SUBJECT: Data Request #1 for the SDG&E San Marcos to Escondido TL6975 69kV Project
ISMND

Data Request #1

SDG&E San Marcos to Escondido TL6975 69kV Project

Presidential Substation, 207584.02
Figure 2-5
 Substation Profile View

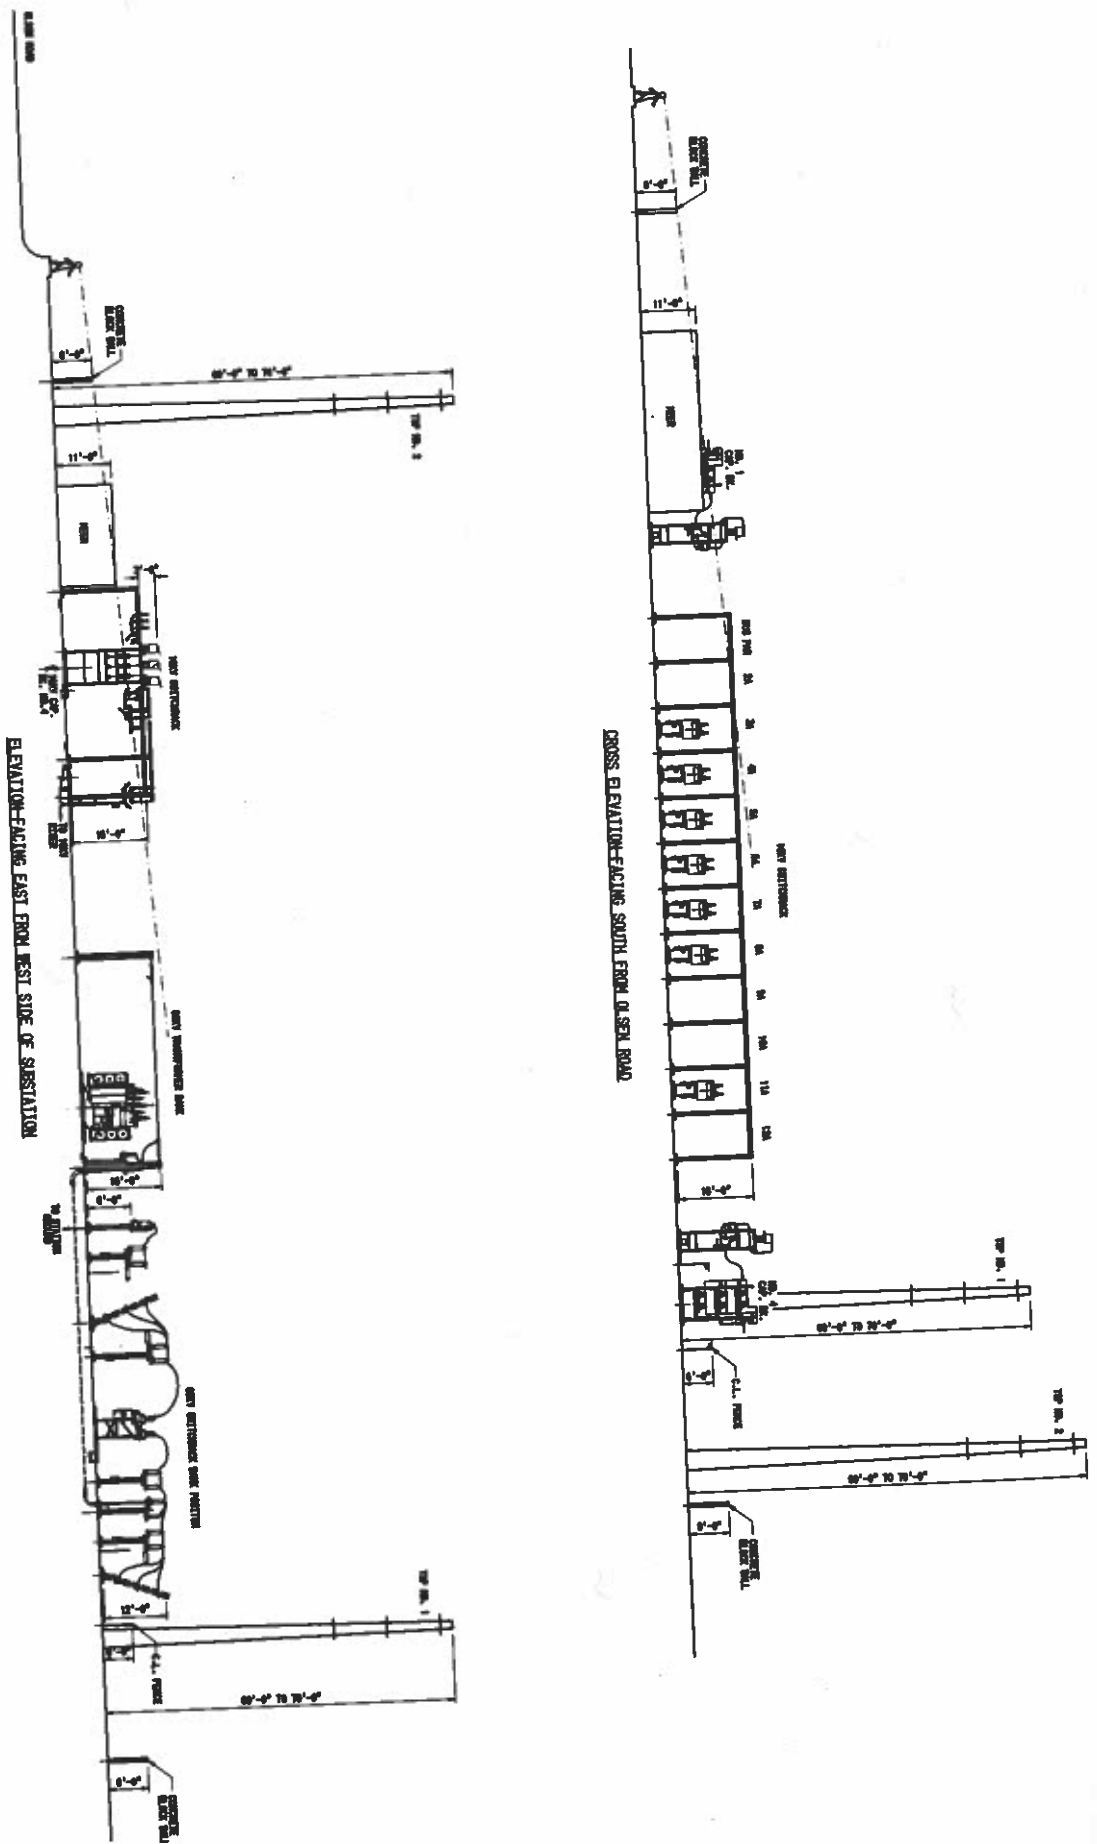
7. Please provide a clearer and more detailed Profile Elevation view of the San Marcos substation. That provided in Attachment 2A of Deficiency Response #1 is not clear. To assist, an example view is included as Attachment A. Also, for the visual analysis, the wall enclosing the substation should be shown.
